UNITED STATES PATENT AND TRADEMARK OFFICE

Office Action Summary

10/585,387

DETAILED ACTION

a stop tooth **A** (Figure 1 reprinted below with annotations) disposed on the lock plate; and

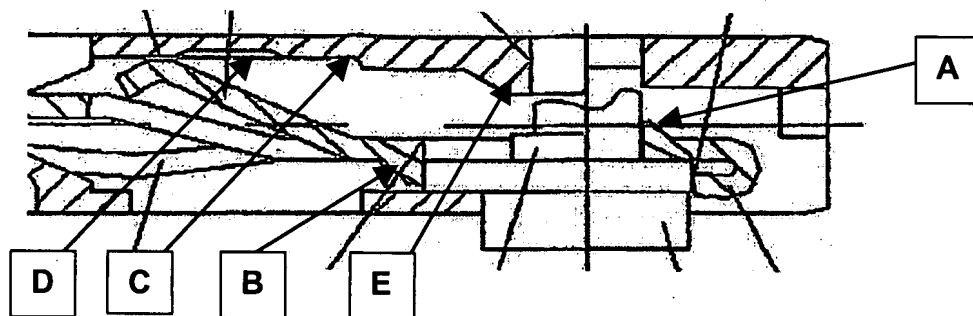
As to claim 9, Applicant's Admitted Prior Art (Figures 1-3) discloses a connecting lock for exhibition stands, the connecting lock comprising:

a lock shell **1** having inclined bearing surfaces **121,221** in a front portion thereon;

a lock plate **2** having a front end and a back end, a plurality of plate tongues **1010,1011,1012** being disposed at the front end of the lock plate, an end of each plate tongue being bent into a hook **21,22,23** with a reverse bending direction between

adjacent hooks and each plate tongue having a beveled surface, the plate tongues being separated by a plurality of elongated slots **1001,1002**, each slot being divided into three sections **41,42,43** of different widths;

an eccentric lock cam **3**, having an eccentric cam, the lock plate being inserted into the lock shell, and the eccentric lock cam being inserted through a first hole and a second hole **5**, and into a third hole **53**, wherein the first hole has an arc and the first hole and the third hole are formed in the lock shell, and the second hole is formed in the lock plate,

wherein the eccentric cam on the eccentric lock cam and the stop tooth on the lock plate constitute a stop structure (Figures 1-3).

As to claim 10, Applicant's Admitted Prior Art (Figure 1) discloses a connecting lock comprising a barrier tooth **B** on the lock plate **2**.

As to claim 11, Applicant's Admitted Prior Art (Figure 1) discloses a connecting lock wherein a first rectangular hole **C** is formed on an upper surface of the lock shell **1**.

As to claim 12, Applicant's Admitted Prior Art (Figure 1) discloses a connecting lock wherein a second rectangular hole **D** is formed on an upper side of the lock shell **1**.

As to claim 13, Applicant's Admitted Prior Art (Figure 1) discloses a connecting lock comprising a flange strip **E** disposed on an internal surface of a bottom side of the lock shell **1**.

As to claim 15, Applicant's Admitted Prior Art (Figure 1) discloses a connecting lock wherein the back end of the lock plate **2** is bent into a U-shaped half-loop **26** having an end surface that is a planar.

As to claim 16, Applicant's Admitted Prior Art (Figure 1) discloses a connecting lock comprising a wedged bulge **26** disposed on the lock plate **2**.
